Subject: RE: Photos 12 March Okahu Viaduct and Okahu precast deck at Wilson Precasting, Otago - Confidential

PŪHOI TO WARKWORTH MOTORWAY

Subject	12-11 OKAHU VIADUCT	Discipline	STRUCTURAL
Title	PRECAST DECK PLANKS REINFORCEMENT DETAILS - SHEET 3	Drawing No	P2Wk-DRG-SE-19-0107
		Rev	1

Subject	12-12 PŪHOI VIADUCT
Title	PRECAST DECK PLANKS REINFORCEMENT DETAILS - SHEET 3
Discipline	STRUCTURAL
Drawing No.	P2Wk-DRG-SE-18-0107
Rev	1

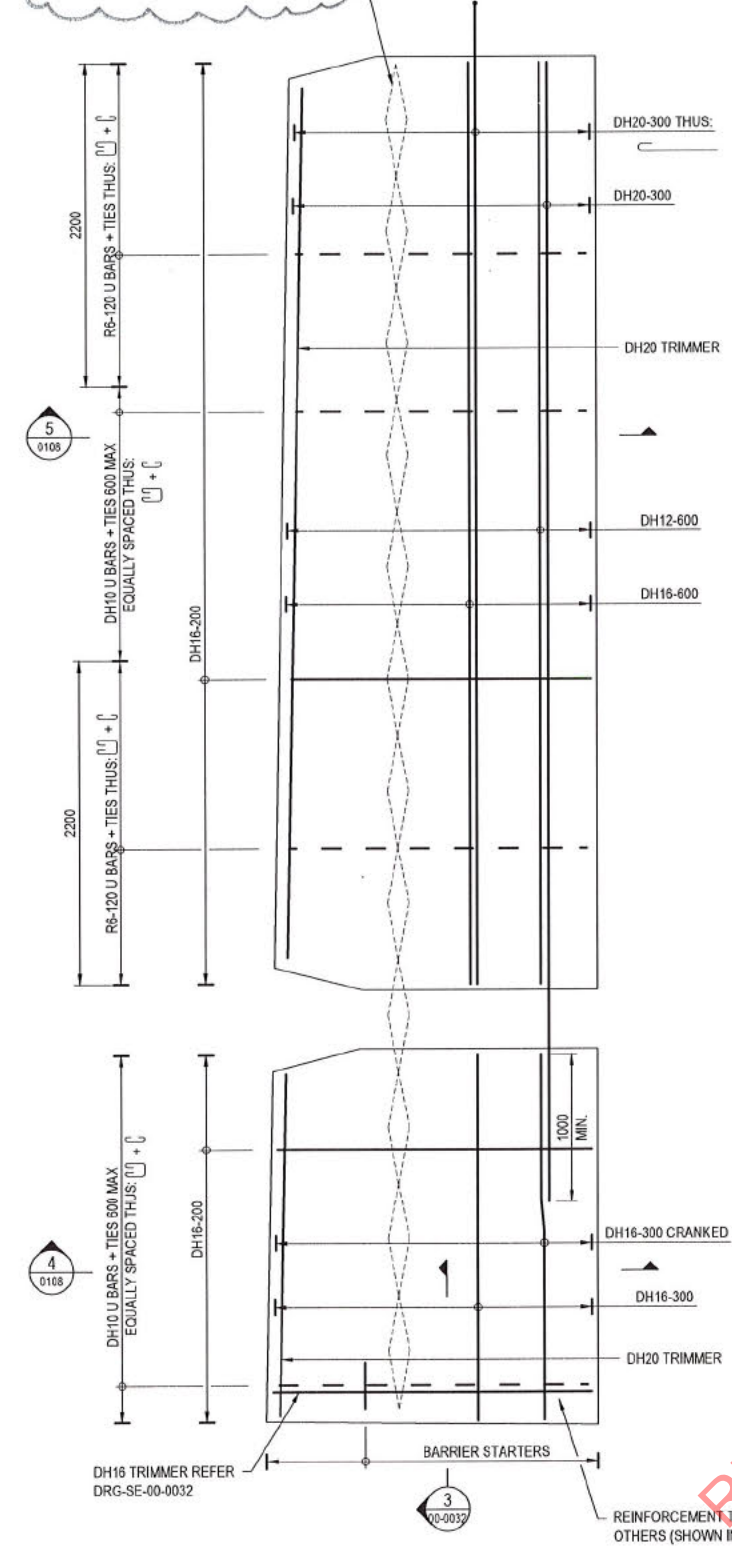
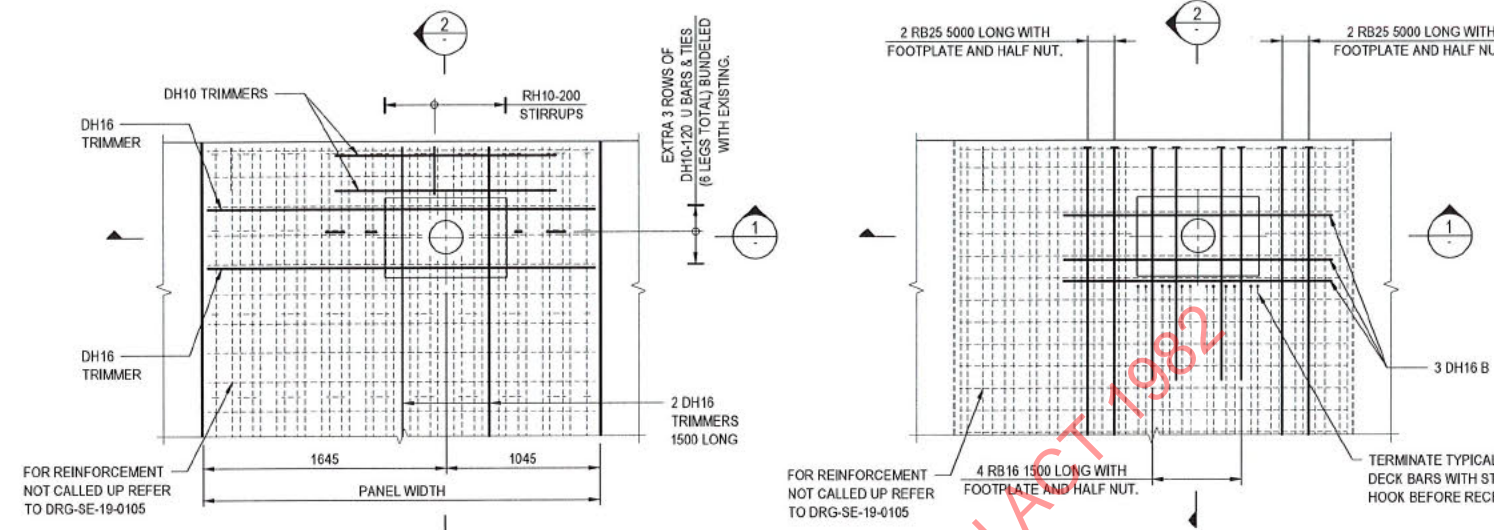
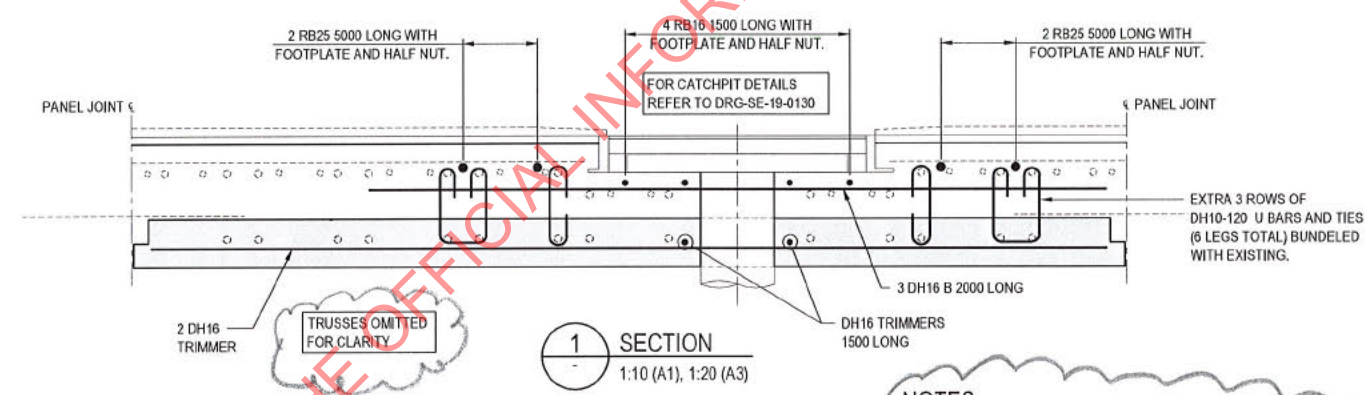
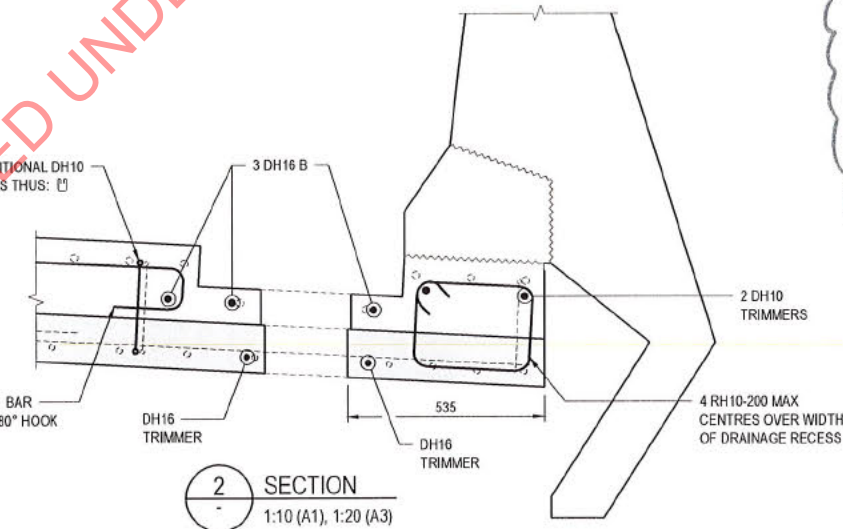
The problem is the on-going effects on the deck slab behaviour due to a number of discrete changes in deck stiffness resulting from the fracture of the welded reinforcement truss. I have explained how I think the deck failure mode will be arrived at and I have implied this is likely to come about in much less than 100 years design life giving rise to both safety and durability issues. Given the stage and commercial organisation of the project stating the bald engineering will be unpalatable, but my view is s 9(2)(a) cannot be drawn into the design of a potentially flawed bridge deck system that is fraught with danger. We can assist with the design of an alternative deck system with a 100 year design life if NX2 are unable to get sign-off of the welded reinforcement truss or prove this system is adequate for 100 years.

By my calculations based on an assumed number of 6t axles and AASHTO detail classification E the Temporary Reinforcement Trusses will fail within the first year.

- THE TEMPORARY REINFORCING TRUSS IS CONSIDERED REDUNDANT FOR THE PERMANENT WORKS DUE TO FATIGUE ISSUES CAUSED FROM WELDING OF THE TRUSS BARS.
  - THE CONSTRUCTOR SHALL PROVIDE ADEQUATE LATERAL SUPPORT TO PREVENT THE PRECAST PANEL FROM DISPLACING OFF THE STEEL GIRDER FLANGE.

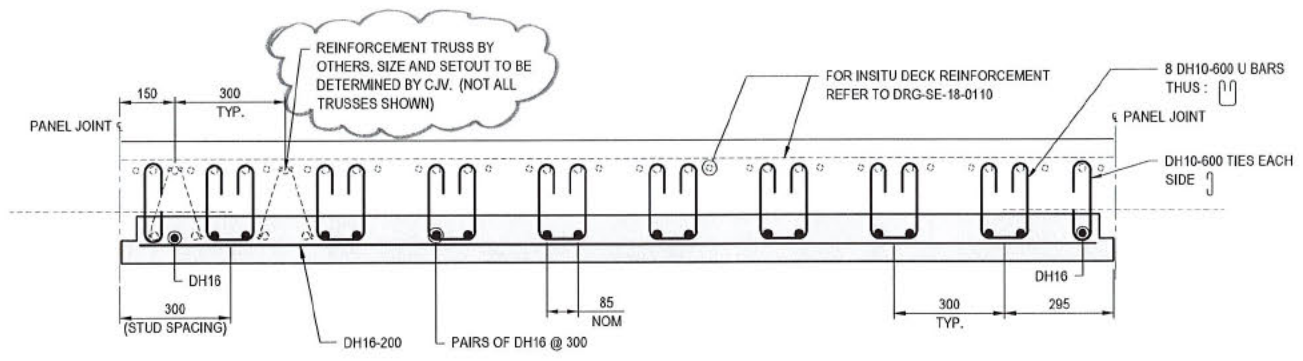
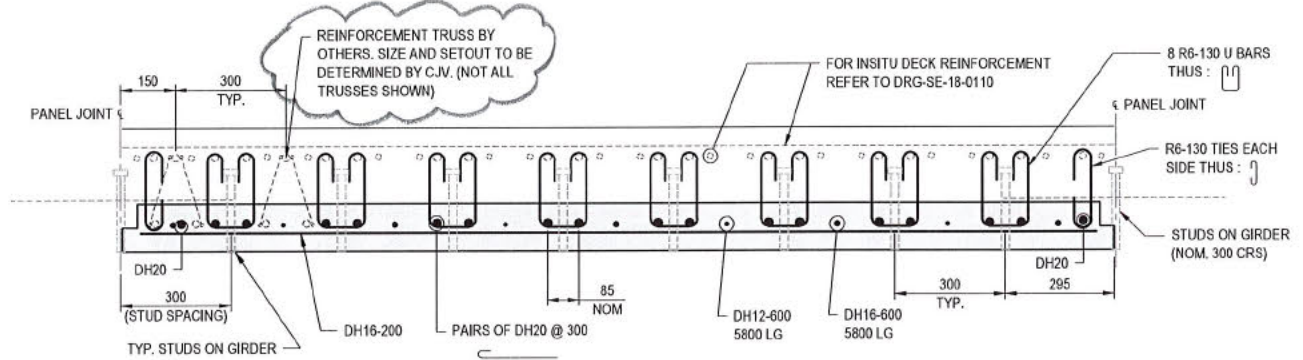
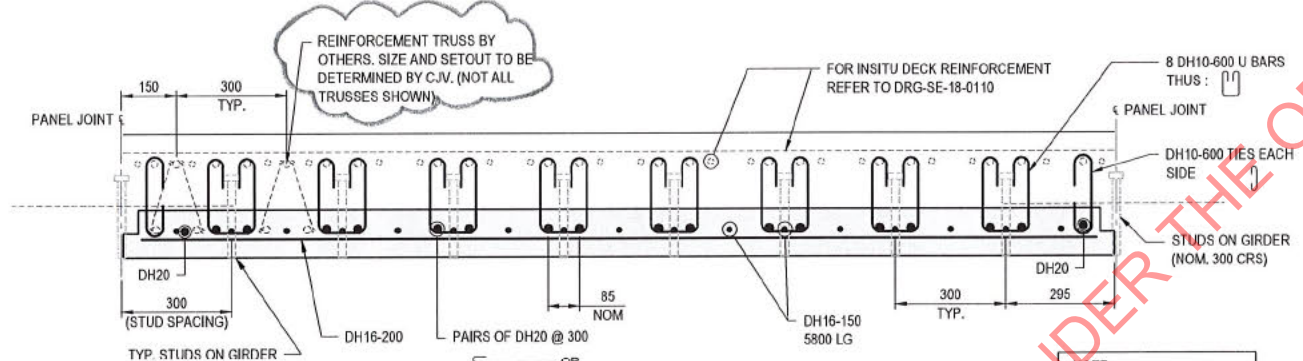
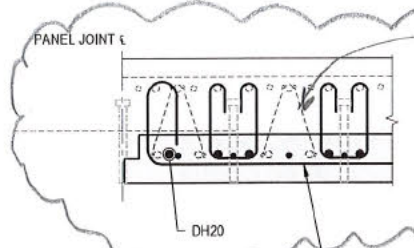
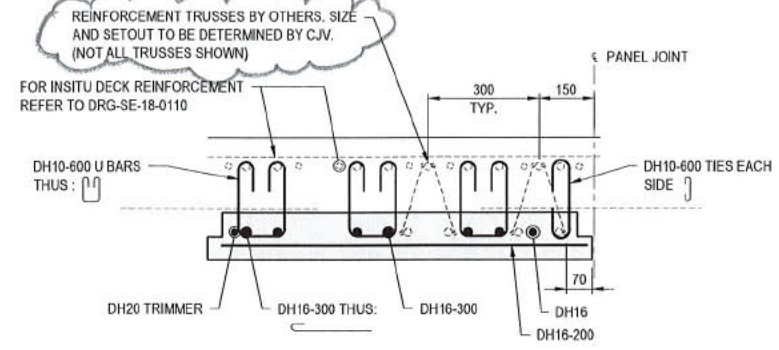
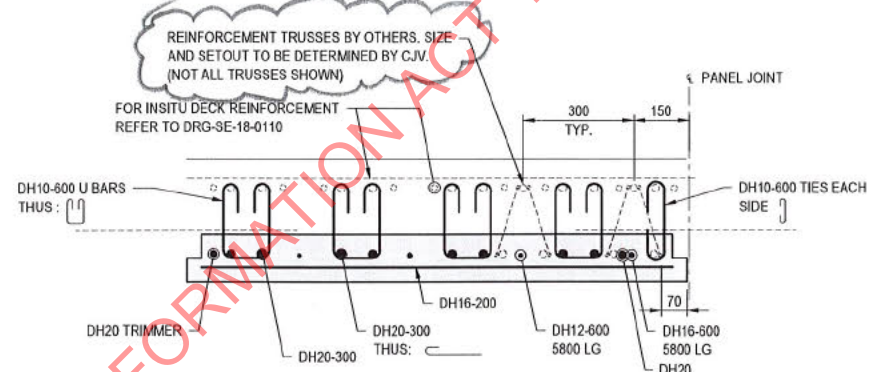
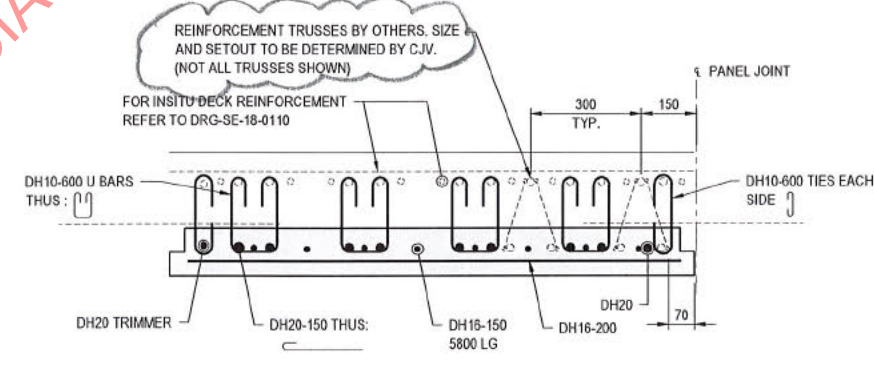
<p>2. High deck curvatures at locations of fatigue fractured Temporary Rebar Truss. There seems to be a gap between the allowable fatigue stress range and the actual stress range based on reasonable assumptions of detail category and number of load cycles. The longer</p>	<p>The designers clearly understood that the Temporary Rebar Truss would suffer from fatigue effects as it is mentioned in the Construction drawings. It is therefore concluded that the designers assumed that fatigue cracking will occur through the welds only; not the truss chords. (Please note that 'Temporary' is regarded as a misnomer because the trusses are permanently and completely embedded within the permanent deck slab.) Assuming a Detail Category E (from AASHTO and AREMA bridge codes) and an estimated 1 million load cycles of 6tonne axles per year it was calculated the Temporary Reinforcement Truss will fracture</p>

The second failure mode comes about from the sudden changes in deck stiffness caused by the design intended and highly likely fatigue fractured TRT's cast into the permanent deck slabs. This failure mode is subordinated to the first because should the first occur this will prevent the viaduct decks being constructed as currently intended.
